HISTORIC PRESERVATION COMMISSION REPORT

Case Name: McDonnell Window Replacement

Case Number: 8-HP-2016

Request: Request approval of a Certificate of Appropriateness - Historic Preservation and Historic Residential Exterior Rehabilitation (HRER) funding to replace existing windows with new energy efficient windows.

ATTACHMENT #5

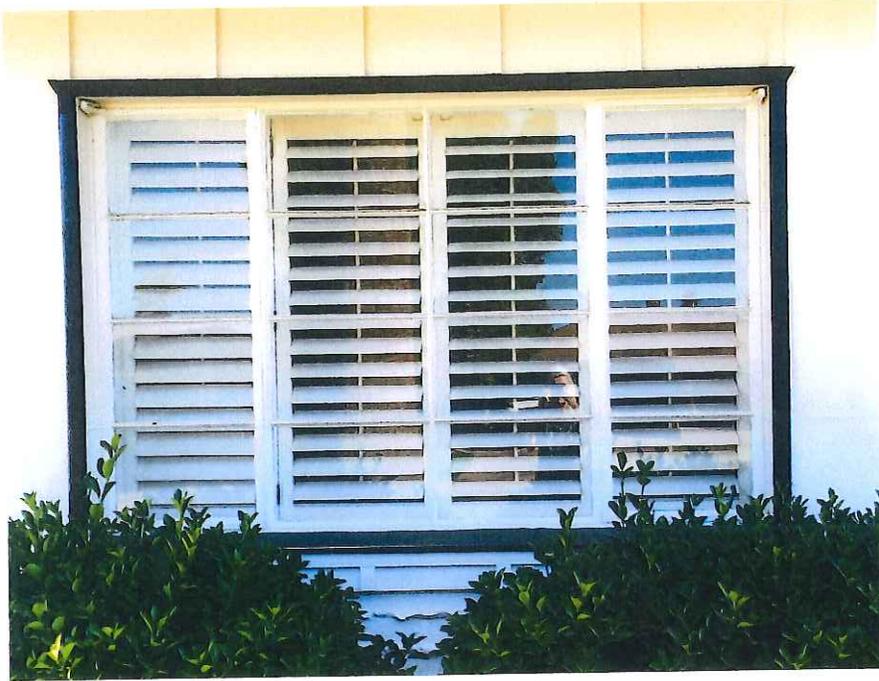
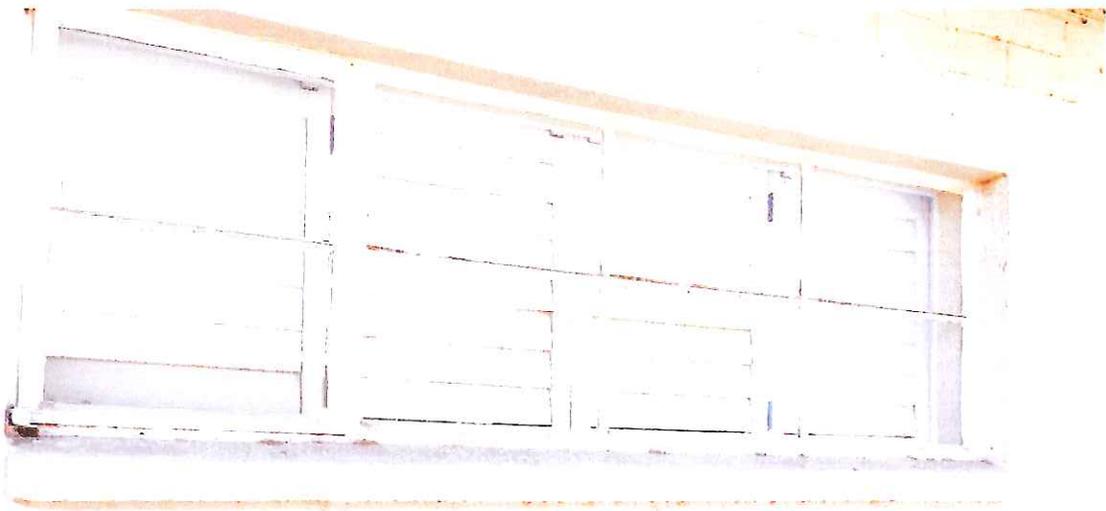
The windows that can be seen from the street follow the original muntin pattern with a muntin width of less than an inch. The muntins are not true or simulated through-the-glass muntins, the grid pattern is between the panes of glass. The windows being replaced in the rear of the home are proposed to not include muntins.

The operation of window #10, the large front window, is a casement window and will be replaced with a casement window. The other nine (9) windows are proposed as slider windows to provide improved fire egress.

The large front window (#10) will be the only casement window. We had planned to have all of the windows that show from the street casement, but according to the manager of Krasiva Windows and doors, the grid will not match up on windows #1, #2, and #9 if they are casement, and the grid will not match up on #10 if it is a slider. That means in the front, three windows will be sliders, one a casement. The windows in the back of the house will not have grids.

1. For windows located on the primary façade of the home, the muntins shall be on the exterior of the glass, or true or simulated through-the-glass muntins.
2. For windows located on the primary façade of the home, the windows shall be casement windows.
